PUBLIC HEARING MEMORANDUM

SUBJECT: Petition #354-19, for SPECIAL PERMIT/SITE PLAN APPROVAL to allow a five-unit

13 and 17 Gardner Street

ZONING REVIEW MEMORANDUM

Proposed Site Plan

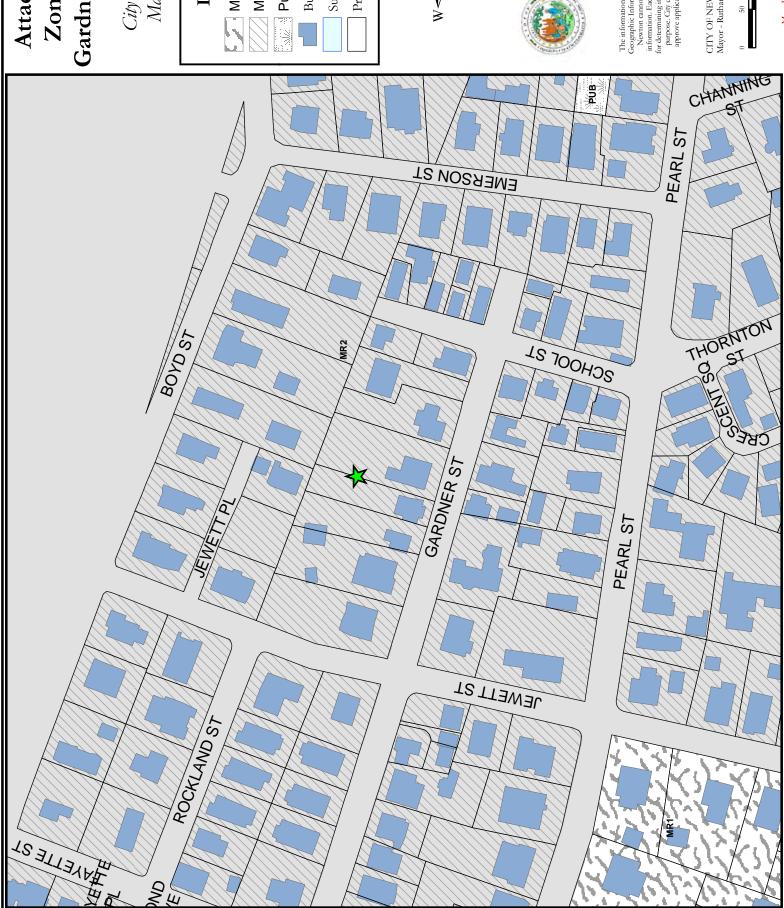
The petitioner is proposing to move the driveway to the eastern boundary to provide access to the garages in the basement. The Planning Department suggests that the petitioner consider extending the lawn area at the eastern boundary to the sidewalk to reduce the amount of paving and to reduce the width of the curb cut. The petitioner is proposing to allocate only one stall to Unit 3 which at 1,488 square feet is the smallest unit, requiring a special permit. Otherwise, the petition complies with the parking requirements. The Planning Department is not concerned with this one-stall waiver due to the unit size, the site's proximity to the Newton Corner village center, and because the waiver preserves open space on site.

The existing curb cut at the western boundary provides access to 17 Gardner Street over the adjacent property at 21-25 Gardner Street. Because the petitioner no longer requires this access, and it appears the abutter does not require the access either, the Planning Department suggests that the petitioner use good faith efforts to work with the abutter to close the curb cut.

The petitioner is proposing to install foundation plantings along the frontage and to create three planting areas and three patio areas at the rear of the site. Vinyl fencing is also proposed for portions of the east and west boundaries. Staff suggests that the petitioner provide a tree removal and protection plan as well as a caliper inch analysis to ensure the there is no net loss of caliper inches on site.
